Access Compliance Report

Public Rights-of-Way

Intersection ID: 11972	Main Street: N_POPLAR_ST	Cross Street: W_5TH_ST	Location: E
ADA ID: DD67202AF795	Ramp Type: PerpDiag	Initial Pass/Fail: Fail	Overall Compliance: No
		Severity Score: 12.5

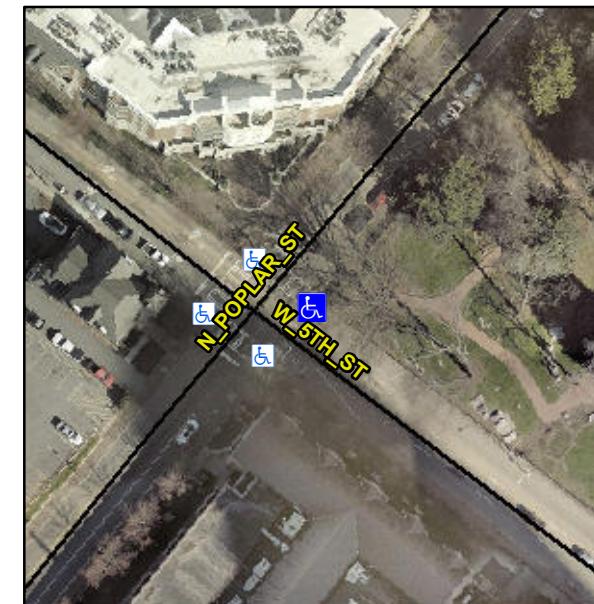
R304.5.3

Compliance	Description	Data	Compliance	Description	Data
N/A	Ramp Length (in)	77.0	Yes	Ramp Slope (%)	5.7
Yes	Ramp Width (in)	48.0	No	Ramp XSlope (%)	5.1
N/A	Flare Type LT	N/A	N/A	Flare Type RT	N/A
N/A	Flare Slope LT (%)	N/A	N/A	Flare Slope RT (%)	N/A
N/A	Flare Traversable LT?	N/A	N/A	Flare Traversable RT?	N/A
N/A	Landing Length (in)	N/A	N/A	DWS Provided?	N/A
N/A	Landing Width (in)	N/A	N/A	DWS Contrast?	N/A
N/A	Landing Slope (%)	N/A	N/A	DWS Length (in)	N/A
N/A	Landing X Slope (%)	N/A	N/A	DWS Full Width?	N/A
N/A	Landing Curb? (Y/N)	N/A	N/A	DWS Offset (in)	N/A
N/A	Shared Landing?	N/A			
N/A	Gutter Ponding?	N/A	N/A	Gutter Slope (%)	N/A
N/A	Gutter Lip Ht (in)	N/A	N/A	Gutter X Slope (%)	N/A
N/A	Painted X Walk1?	Yes	N/A	Painted X Walk2?	Yes
	X Walk 1 Direction	To NW		X Walk 2 Direction	To SW
N/A	X Walk 1 Width (in)	112.0	N/A	X Walk 2 Width (in)	112.0
	X Walk 1 Slope (%)	1.6		X Walk 2 Slope (%)	3.0
	X Walk 1 X Slope (%)	7.6		X Walk 2 X Slope (%)	1.0

Remove & Replace Curb Ramp With Two New Directional Ramps or Equivalent.
